SNUPPS

Standardized Nuclear Unit
Power Plant System

September 14, 1981
SLNRC 81-101 FILE: 0541
SUBJ: RSB Review

Agenda item #5 of the July 21, 1981 meeting concerned Refueling Water Storage Tank sizing and setpoints. Enclosure A to this letter is FSAR changes that provide the required information and will be incorporated in the next revision to the SNUPPS FSAR.

SNUPPS
FIGURE 6.3-7
RWST LEVELS AND VOLUMES

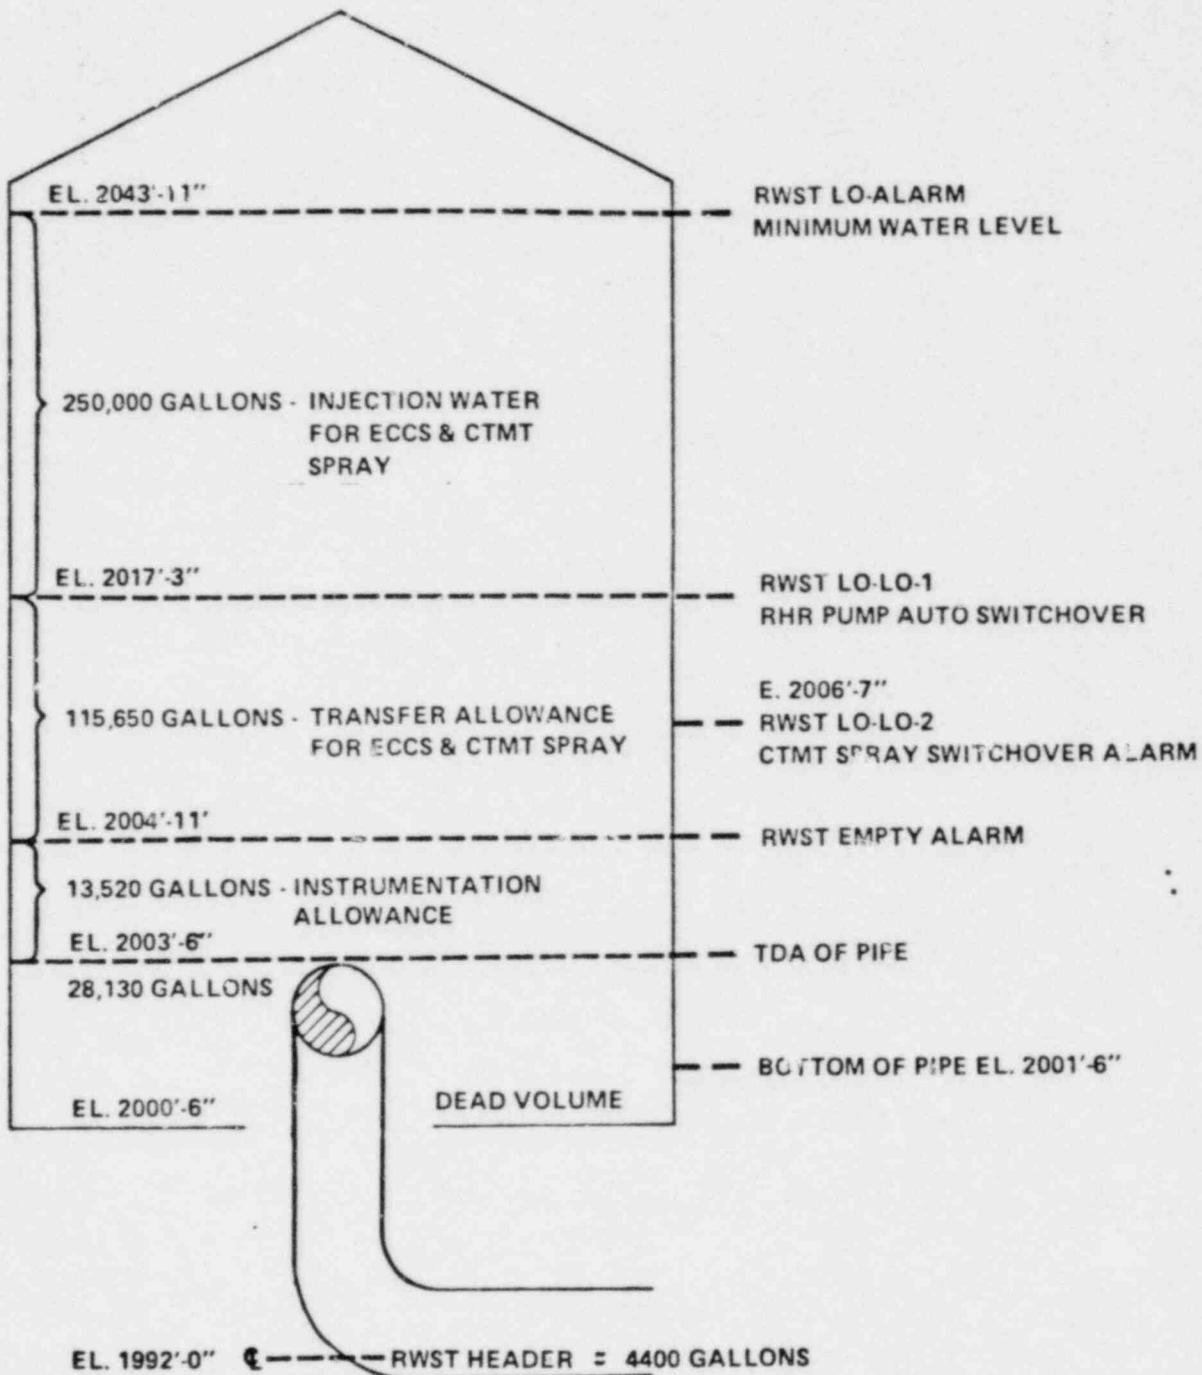
Since the RWST is not normally used as a source of water during power operation, the tank level is administratively maintained. The water level is maintained above the minimum level consistent with the 250,000 gallons required for injection, transfer allowances, and instrument error allowances. The RWST levels and volumes shown on Figure 6.3-7 are based on the following considerations.

As shown on Figure 6.3-7, the total transfer allowance for ECCS and containment spray pump switchover is 115,650 gallons. In the worst single failure case, the total outflow from the RWST during ECCS pump switchover is 60,330 gallons, leaving 47,320 gallons for containment spray pump switchover. At the completion of the switchover steps listed in Table 6.3-12, 12,680 gpm is being drawn from the RWST by two containment spray pumps, and the RHR pump and sump line are still lined up to the RWST due to failure of HV 8812A or B to close.
